Ku-ring-gai Council: heritage comments on Lindfield Learning Village Stages 2 and 3

Heritage impact external

Figure 2: Level 4, proposed are of slab to be removed circled in red

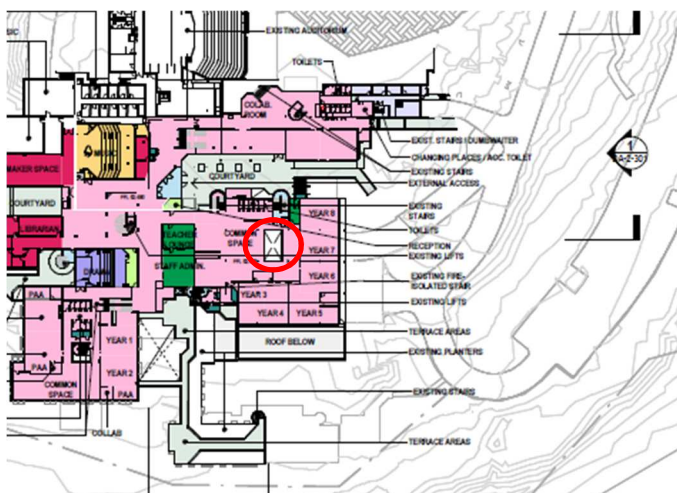
7. Demolition of slab level 4 zone courtyard for light well

The partial demolition of the slab on level 4 and above the former library to improve light penetration will result in the minimal loss of original fabric. The “horizontal window” or glass flooring is the preferred option for the treatment of the new opening.
